Date: 13 December 2019

Ref: 32859YFlet

GEOTECHNICAL PEER REVIEW
PROPOSED RESIDENTIAL DEVELOPMENT
3 BERITH STREET, WHEELER HEIGHTS, NSW

TYPE SECTION – Diagrammatical Interpretation of expected Ground Materials

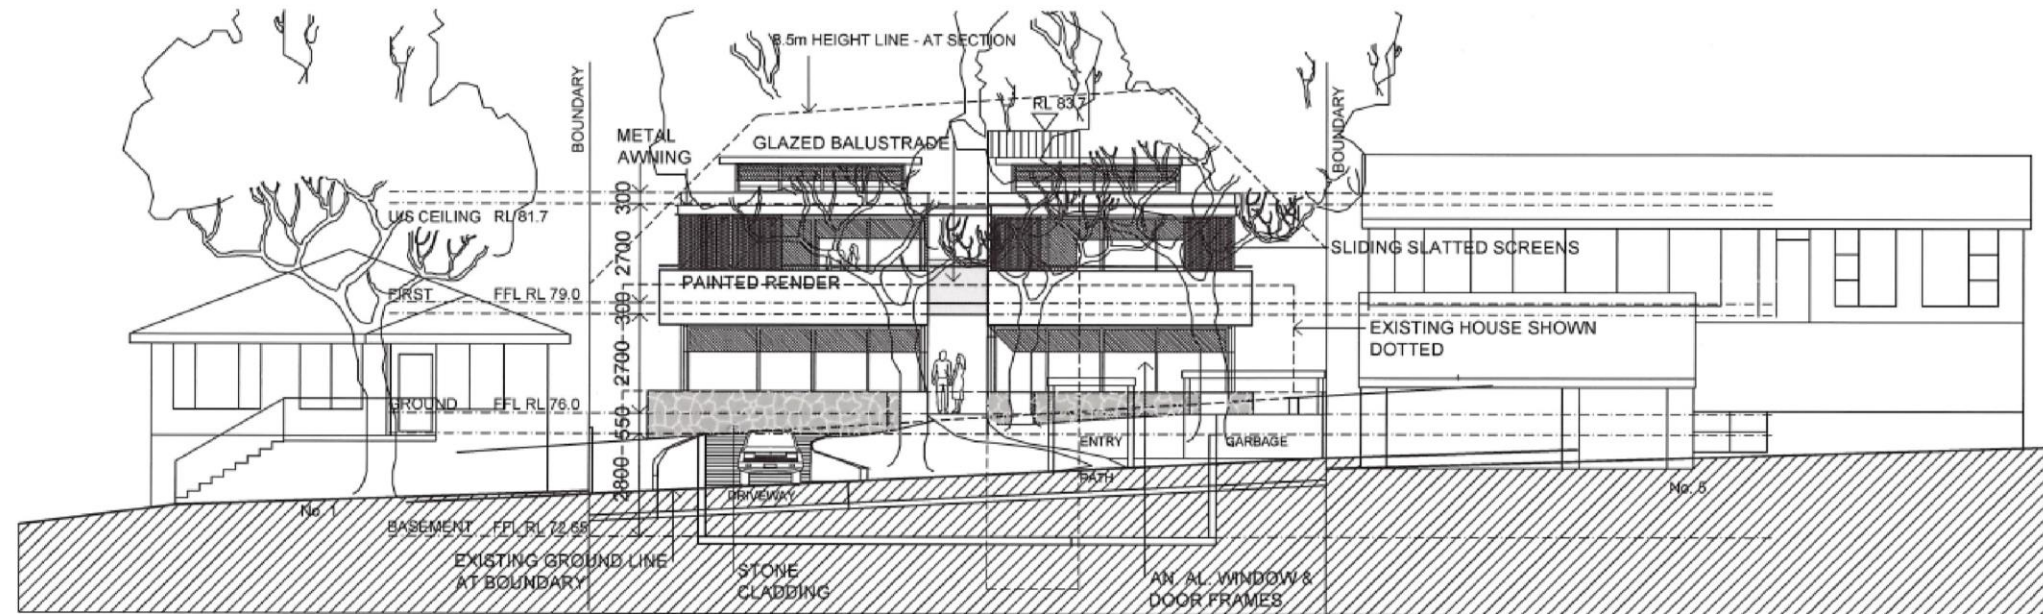
1. We do not understand the comment "This material [medium strength sandstone] is expected to be exposed across most of the base of the excavation". From our assessment and reference to the 'Type Section' contained in their report, the bedrock should be uniformly exposed over the entire basement footprint, unless they are also referring to excavations outside the basement.
